# La Marzocco Technical Bulletin #109

## New T Fitting for Silicone Tube

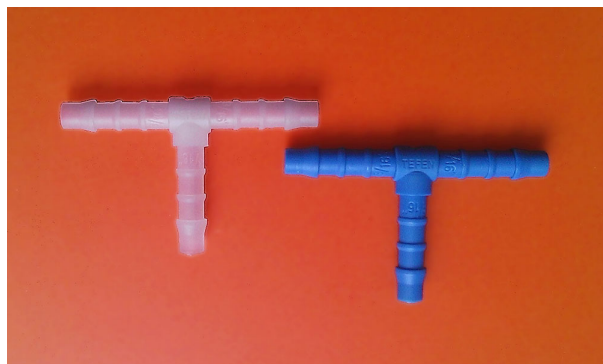
We have upgraded to a new high temperature plastic material (white) which replaces the previous Nylon (blue) fitting with the same dimensions. This new product has a superior lifespan and decreased replacement operations which supports the increased cost for the material.

The new spare part code is A.7.001.01, and the new T fittings are already available for order through the Parts Department.
